Application for Variation of an Environmental Permit

C2. Application No. of the Current Environmental Permit : EP-580/2020

**Environmental Review Report**

REUSE OF TREATED SEWAGE EFFLUENT FROM  
A TREATMENT PLANT AT  
HONG KONG VIPASSANA MEDITATION CENTRE,  
LANTAU ISLAND

Figure 2: Process Flow Diagram of STP with TSE Reuse System

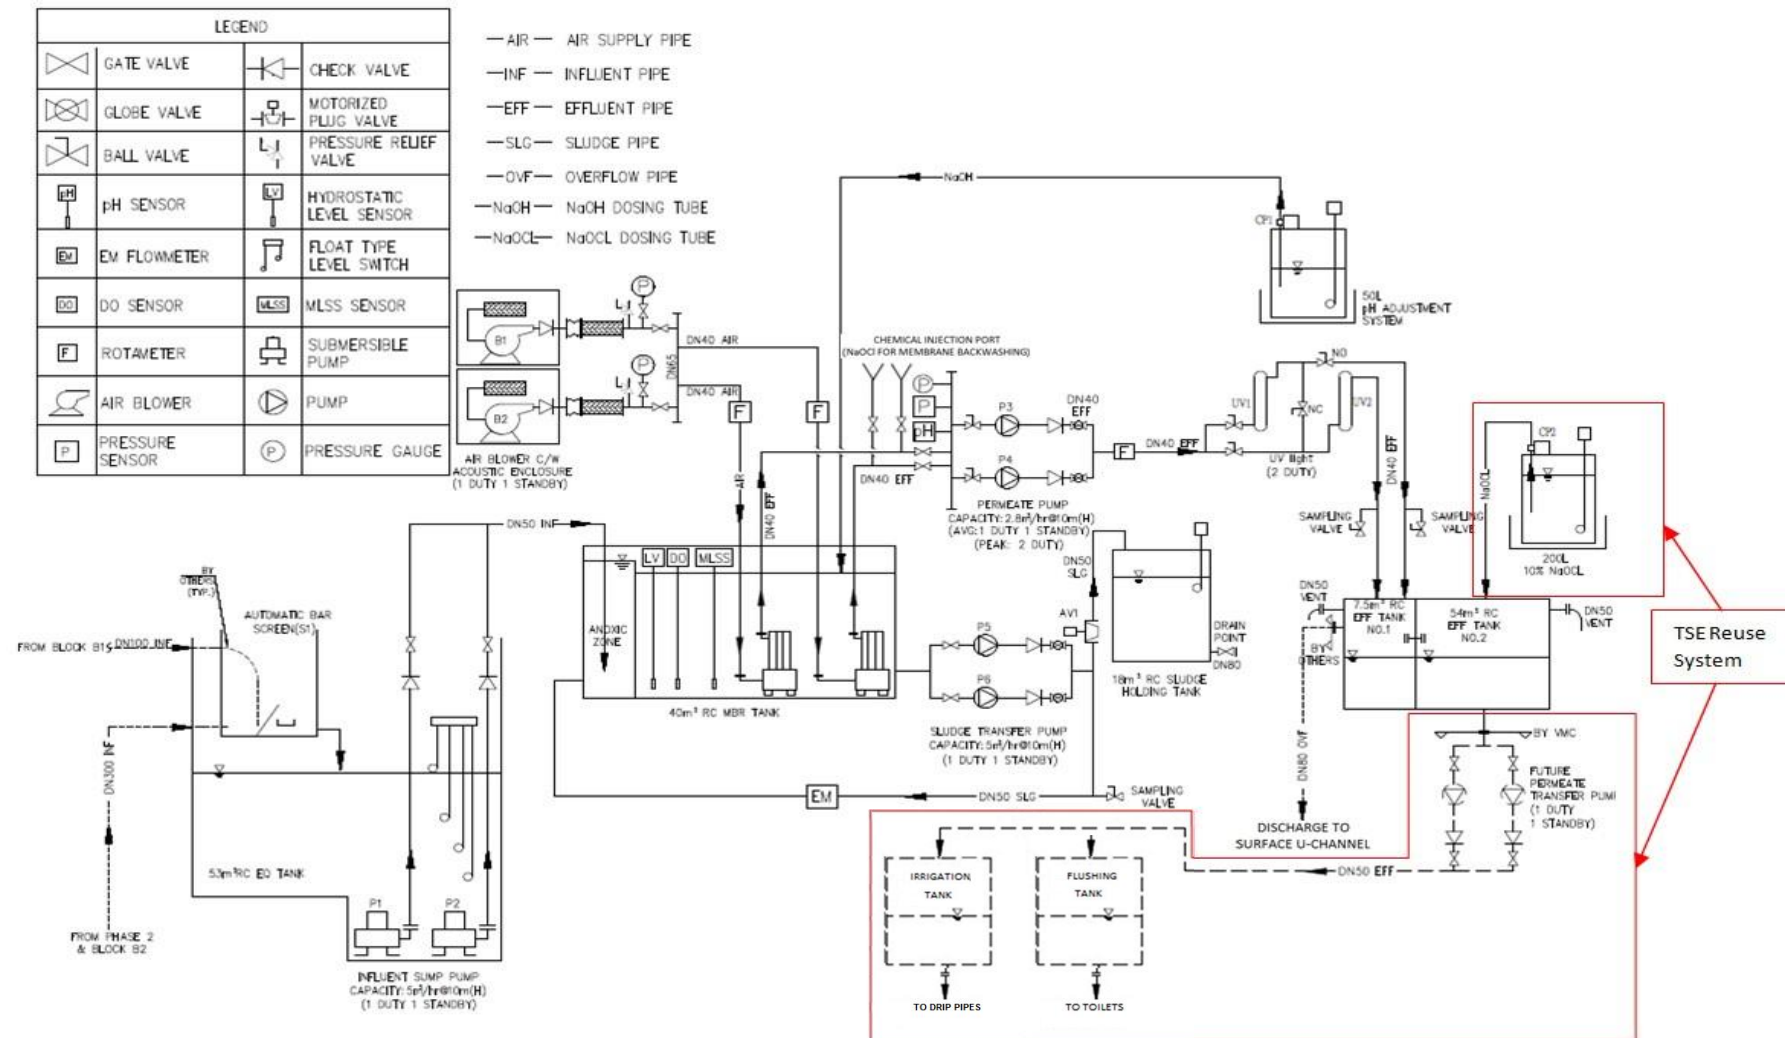
- 1.2.1 The proposed variations mainly involve installation of irrigation tank and drip irrigation system. The treated sewage effluent is now suggested to be reused for both toilet flushing and landscape irrigation. Potable water consumption can be further reduced with the operation of the TSE reuse system for irrigation, and this will contribute to a green and sustainable environment (See Figure 2).

The TSE reuse system is proposed to be modified by installing an irrigation tank storage tank with associated pipelines, which is proposed to be located next to the flushing tank.

The water sample is proposed to be withdrawn from the exit point of the treated effluent holding tank #2 instead of the flushing tank / irrigation tank. As the hilltop water tanks (flushing tank and irrigation tank) will be relocated to the roof of the meditation hall (highest building) in the expected future, climbing of cat ladders is needed for carrying out inspection or water sampling. Due to safety concerns of climbing cat ladder and to avoid disturbing student attending meditating class in the meditation hall, the water sample is proposed to be withdrawn from the exit point of the treated effluent holding tank #2, instead of the flushing tank and irrigation tank.

Figure 4: Locations of Greening Zones and Auto-irrigation timer

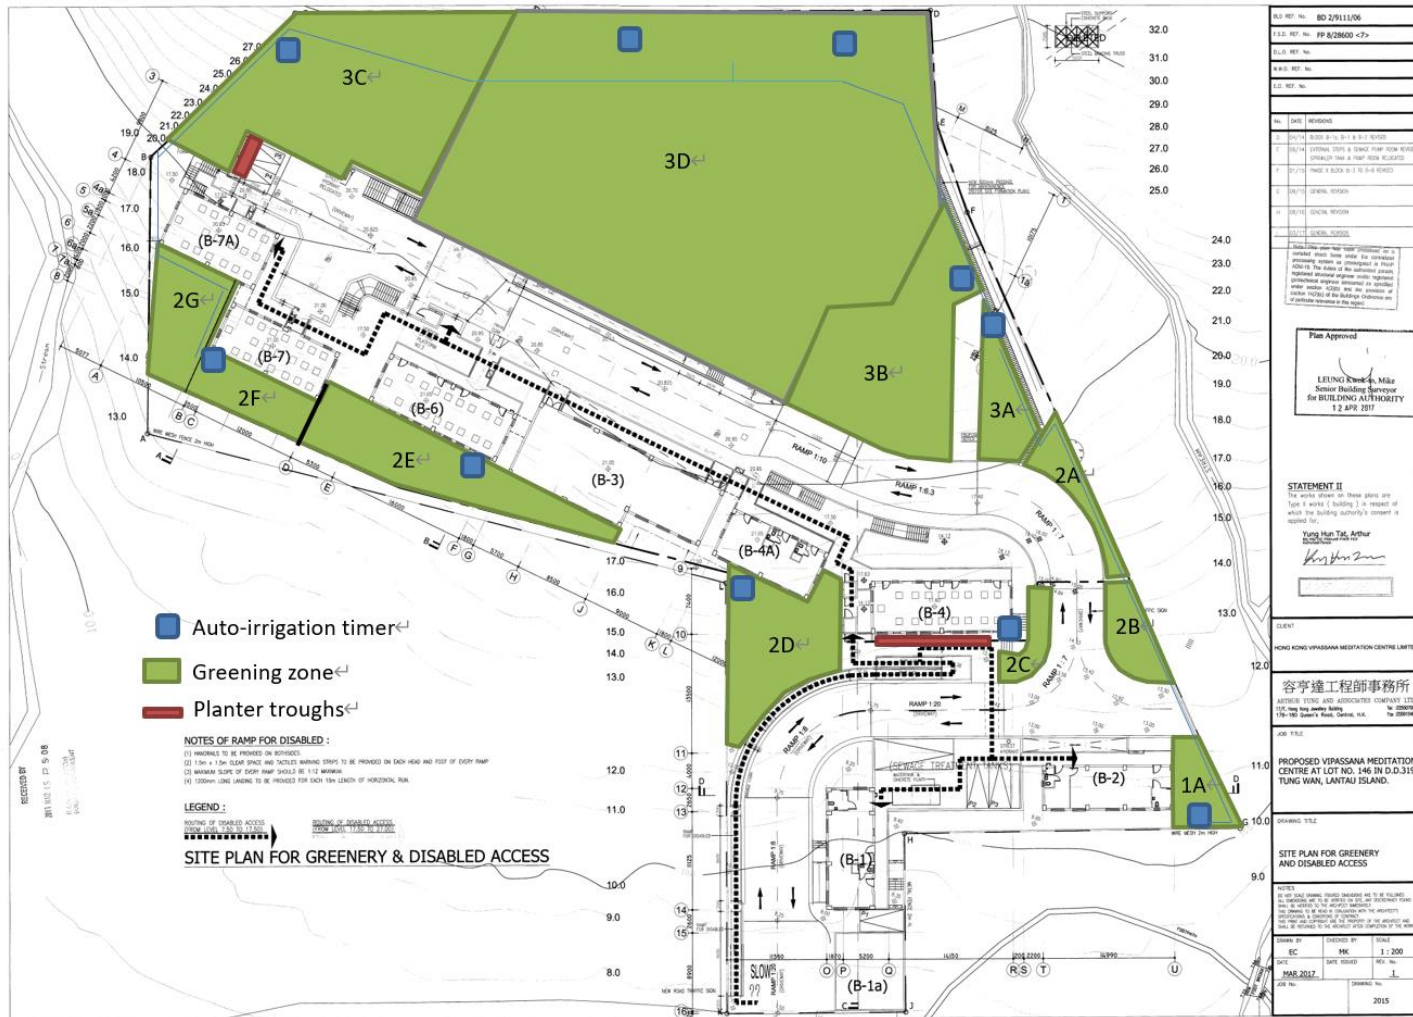
- 1.2.3 A total area of about 3,200 m<sup>2</sup> of greening zones (see Figure 4) is proposed to be irrigated by the treated water. Non-spray irrigation (drip irrigation systems) will be adopted so as to avoid human contact with the treated water.

A total area of about 3,200 m<sup>2</sup> of greening zones (see Figure 4) is proposed to be irrigated by the treated water. In order to avoid human contact with the treated water, non-spray irrigation (drip irrigation systems) will be adopted. Drip irrigation systems distribute water through a network of valves, pipes, tubing, and emitters. “Perforated Pipe Systems” (See Figure 5) will be used for irrigation. Arteries of PVC tube with perforated drip holes will be laid onto the soil ground. A water timer (see Figure 4) is installed with auto irrigation settings of 20 minutes in the morning (06:00-06:20) and 20 minutes in the evening (18:00-18:20) during summer. From the timer, an artery of perforated PVC tube with drip holes (of approximately 1-2 mm diameter) pierced in an interval of 5-8 cm, will be placed / arrayed to cover the soil bed of the plot. An on-the-spot measurement with this irrigation system marked a consumption of 8 litres of water per minute and a two sessions of 20 minutes of irrigation. The duration and other settings of this irrigation system can be adjusted depend on the season and precipitation.
